Technical Service BULLETIN

Title:
SQUEAK AND RATTLE SERVICE TIPS
Models:
'01 Highlander

NV
NV003-02

Introduction To reduce interior squeaks and rattles on 2001 model year Highlander vehicles, the following production countermeasures have been adopted. For vehicles produced prior to countermeasures, perform the following field fix procedures.

Glove Box Door

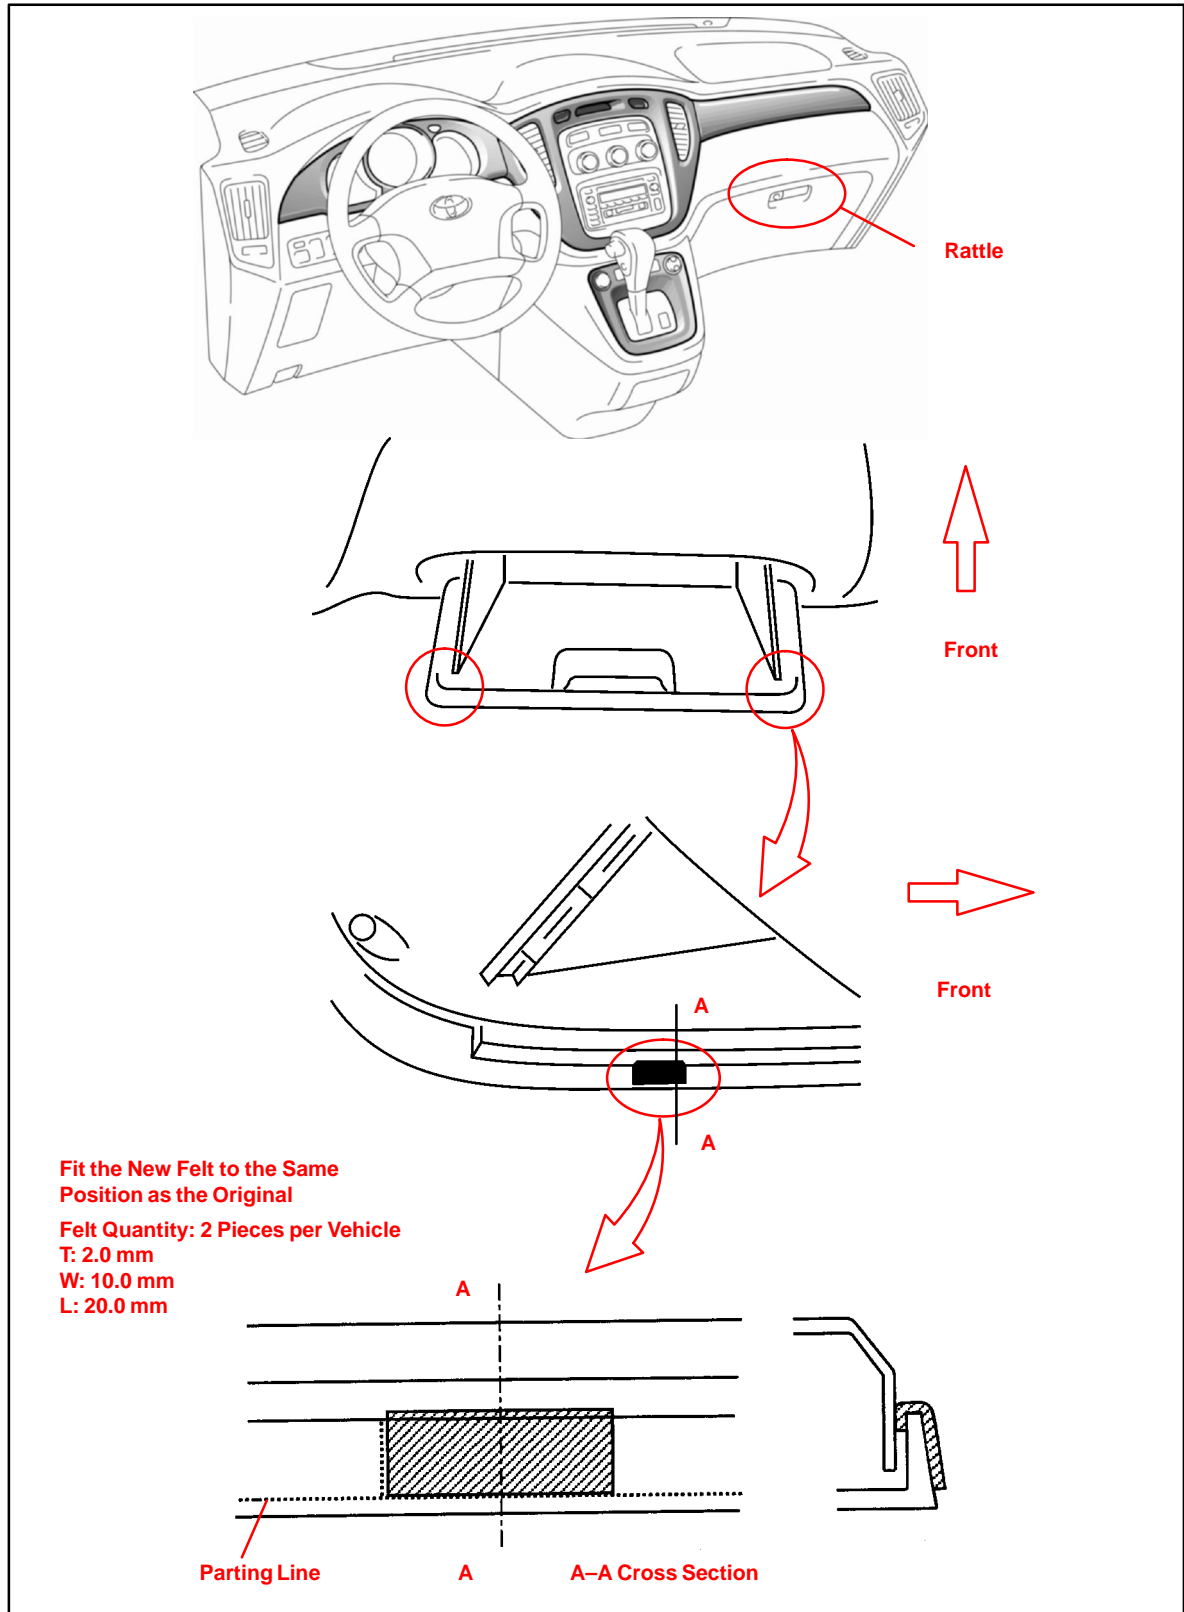
Repair Procedure 1 Replace two pieces of felt fitted to the right and left sides of glove box door with new ones with a thickness of 2.0 mm.

**Repair
Procedure 2**

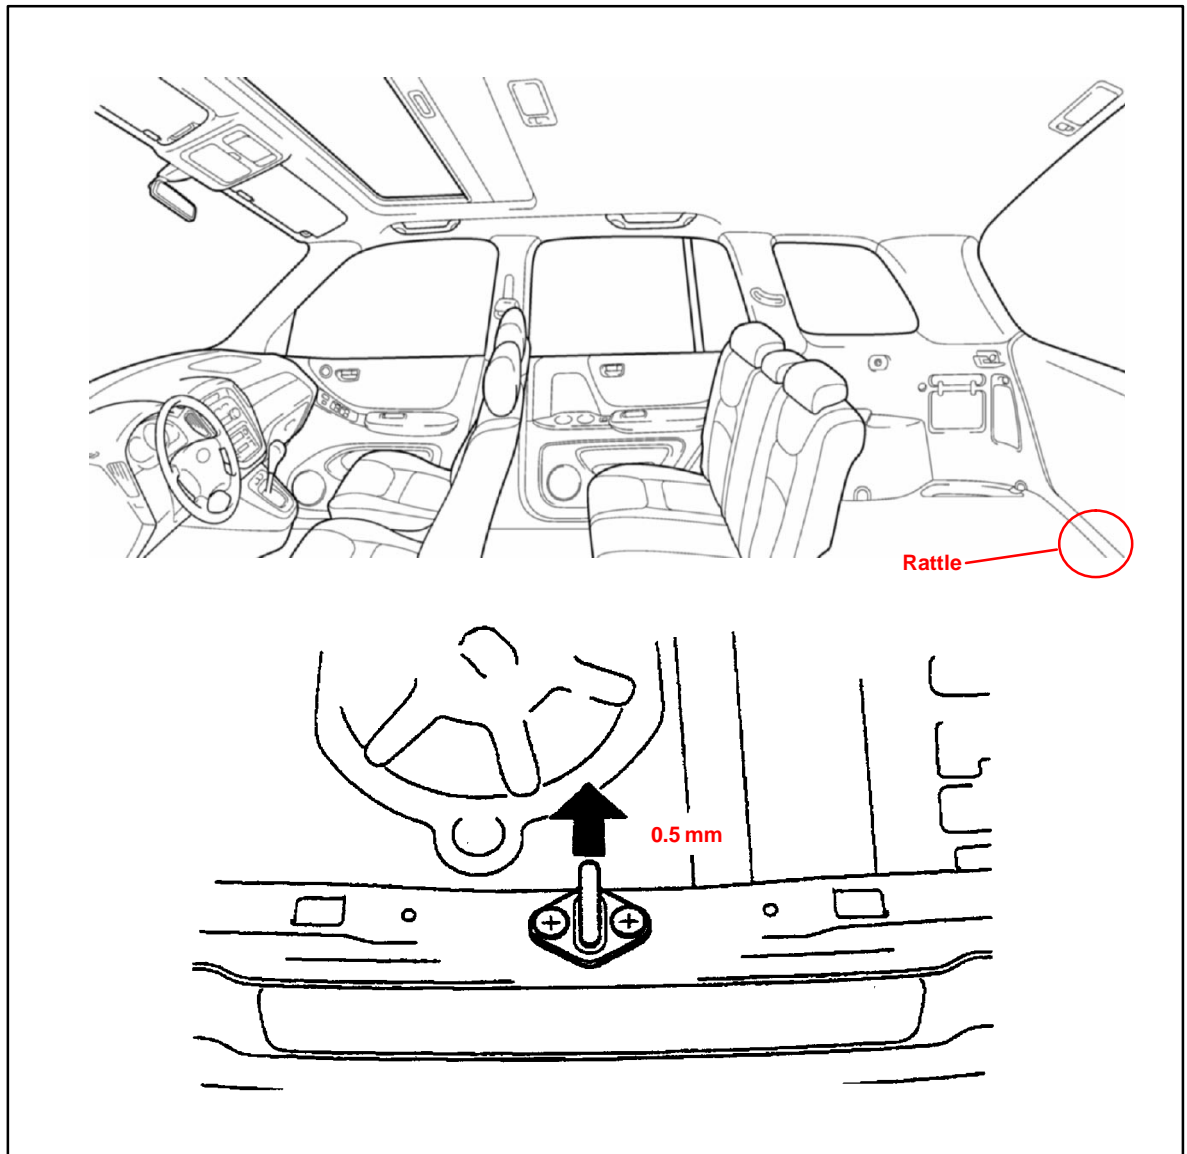
Adjust the back door striker position forward 0.5 mm, as shown below.

Be sure to confirm that the back door can be closed after adjusting the back door striker. The back door will not close if the striker is moved more than 1 mm.
